# COMMITTEE OF THE WHOLE (PUBLIC MEETING) – JANUARY 19, 2021

We appeared before Council last July in response to the two redevelopment proposals for 100 and 180 Steeles Avenue West. This submission is about Chestnut Hill's proposal for 7080 Yonge Street, with two high-rise residential towers, one 20 storeys and the other 40 storeys on top of a 2-storey podium. However, there are many similarities.

Figure 4 – 45-degree angular plane projection (supplied by the Agent) and SFRA projection (red dashed line)

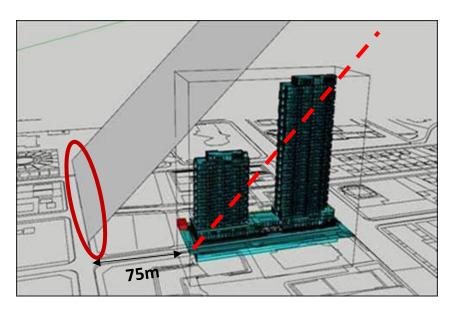
and the smaller tower is 20 storeys, both towers are therefore high-rise. Therefore, we submit that there must be a 7.5m setback to the property line, as illustrated in Figure 3. (The Zoning By-Law amendment proposal requests only a 1.55m setback, which is clearly insufficient for a number of reasons which we will explain.)

However, an illustration subsequently provided directly to SFRA by the agent (see Figure 8 below) indicates that the 45-degree angular plane starts at the eastern side of the southern extension of Powell Road, 75 metres to the west (red oval). The problem with that is that there are four properties between Powell and the western boundary of the site, and they have not been purchased by Chestnut Hill to be added to the site, thus in reality the 45-degree angle would start at the western boundary of the site, (our dashed parallel red line) which would intersect the first building at 1 storey and the second at about 18 storeys. Moreover, if the developer followed the Secondary Plan for publicly accessible green space (10m), [see next section], the property line would be 10 metres further to the east, which would further reduce the height intersect of the second building.

Figure 5 – Yonge Steeles Corridor Secondary Plan Schedule 4 (Parks and Publicly Accessible Open Space)

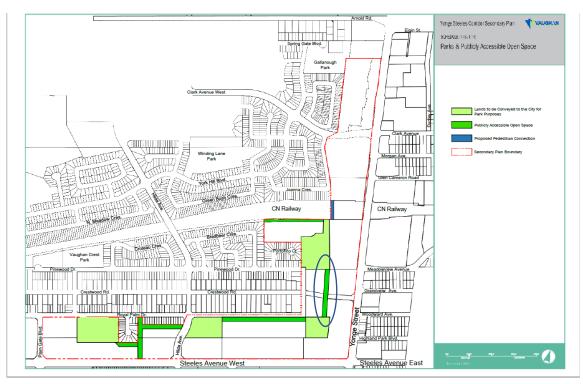
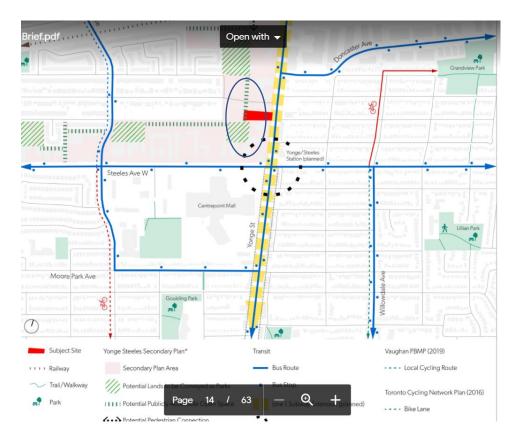
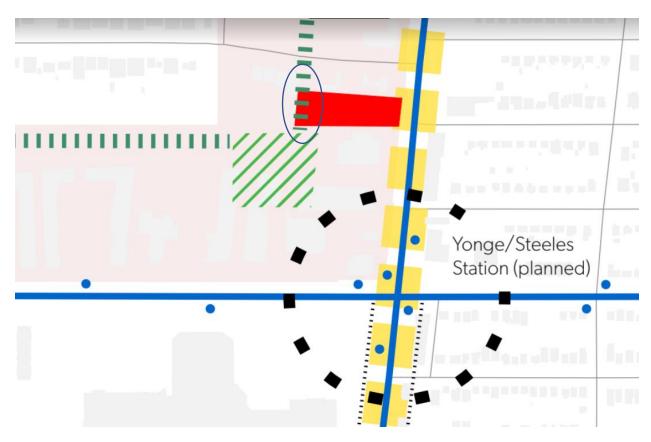
The transition is nonexistent; it is abrupt. In fact, it actually builds over a 10m wide segment of land designated in the Secondary Plan for a "publicly accessible open space" linear park. (see Figures 5, 6 and 7 below, inside the blue oval) The Planning Justification Report is silent on this major detail, and does not draw attention to it, let alone attempt to justify it. The intrusion to the green space park only shows up in Figure 5 of the Urban Design Brief, but again there is no textual reference to it there either. There is no green buffer between the houses to the west and the proposed 20-storey building, and most of the green space is private green roof on the podium for the exclusive use of the buildings' residents.

Figure 10 Lot Coverage and Setbacks (source: 7080 Yonge Limited – Architectural Drawings, p. 4

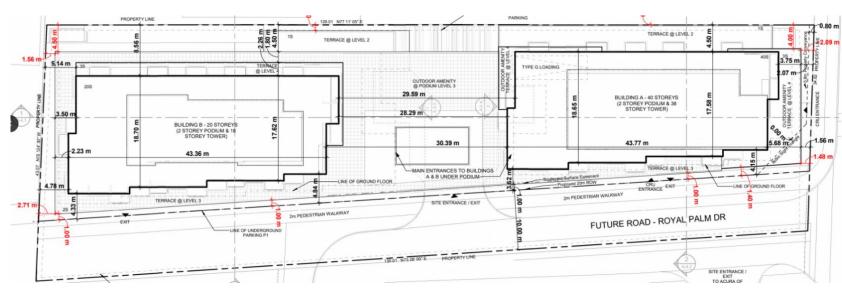
Figure 10 illustrates that the buildings use up approximately 3883/5016m<sup>2</sup> (78%) of the property (including landscaping (Urban Design Brief, Table 2, p. 25)). If we include the private driveway between the buildings of an estimated 905m<sup>2</sup>, the lot coverage is closer to 90-95%. The proposed setbacks from public to private space are 1.48-2.09m on Yonge Street (compared to 7.5m for an RA3 zoning designation the proponent seeks, 0m on the north side (vs. 7.5 for an RA3), 1.0m on the south side (vs. 7.5 for RA3) and 1.56-2.71m on the west side (vs. 7.5m for RA3).

Figure 12 – Shadow Study (Urban Design Brief, p. 59)

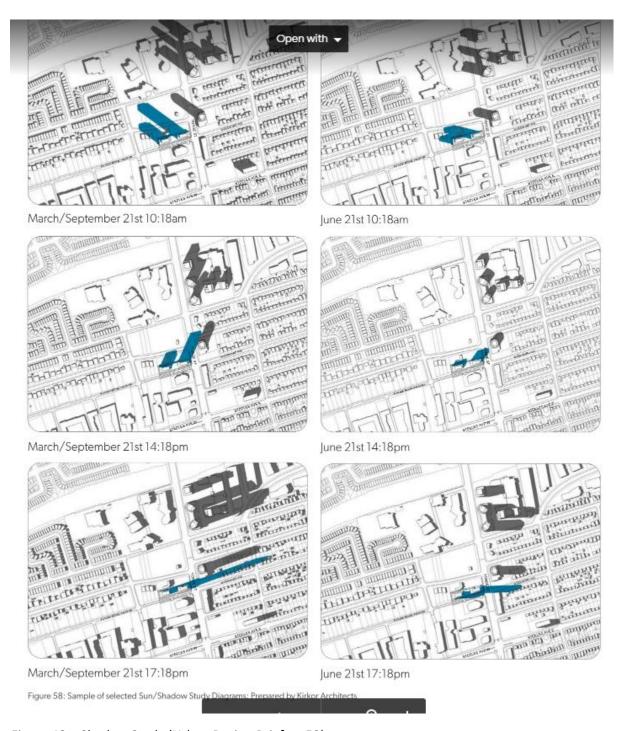
Shadows accrue from building height, massing and siting. The shadow study included in the Urban Design Brief (p. 59) shows strong east-facing shadows onto the Markham side of Yonge Street for March and September at 5: 18pm (see Figure 12)
